Title - Sujet CHURCH SPRINKLER INSTALLATION	
Solicitation No. - N° de l'invitation E0225-142283/A	Amendment No. - N° modif. 001
Client Reference No. - N° de référence du client 20142283	Date 2014-01-31
GETS Reference No. - N° de référence de SEAG PW-\$PWA-123-5054	
File No. - N° de dossier PWA-3-70117 (123)	CCC No./N° CCC - FMS No./N° VME
Solicitation Closes - L'invitation prend fin at - à 02:00 PM on - le 2014-02-06	Time Zone Fuseau horaire Atlantic Standard Time AST
F.O.B. - F.A.B. Plant-Usine: <input type="checkbox"/> Destination: <input checked="" type="checkbox"/> Other-Autre: <input type="checkbox"/>	
Address Enquiries to: - Adresser toutes questions à: Lockyer (PWA), Jeff	Buyer Id - Id de l'acheteur pwa123
Telephone No. - N° de téléphone (902) 496-5636 ()	FAX No. - N° de FAX (902) 496-5016
Destination - of Goods, Services, and Construction: Destination - des biens, services et construction:

Amendment 001 is being created for the following:

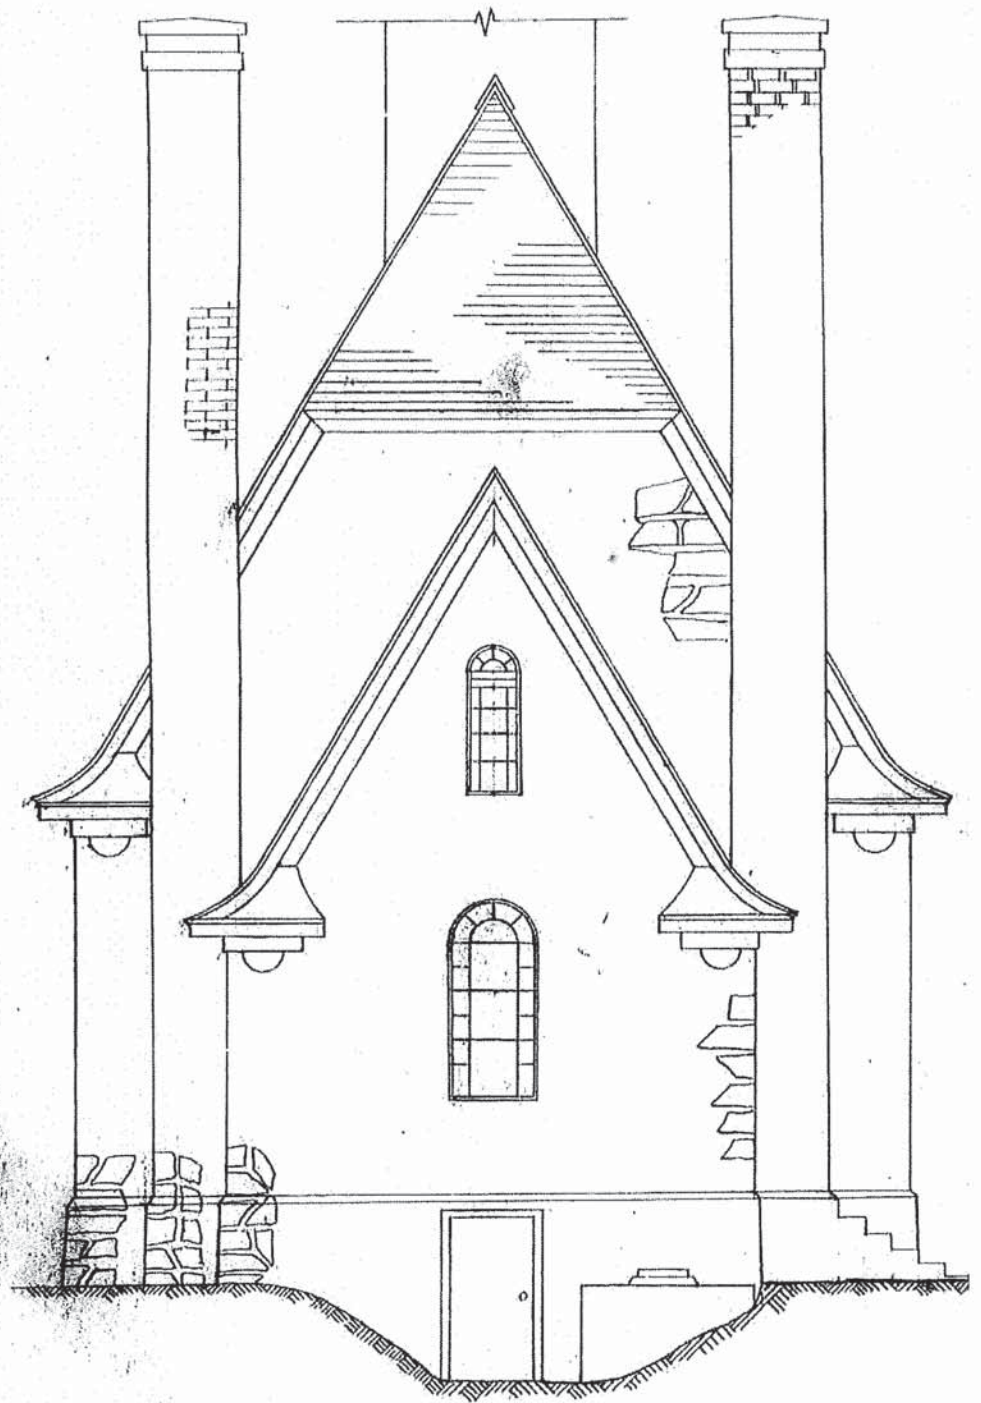
Historical Photos have been included as a reference. (See attached herein)
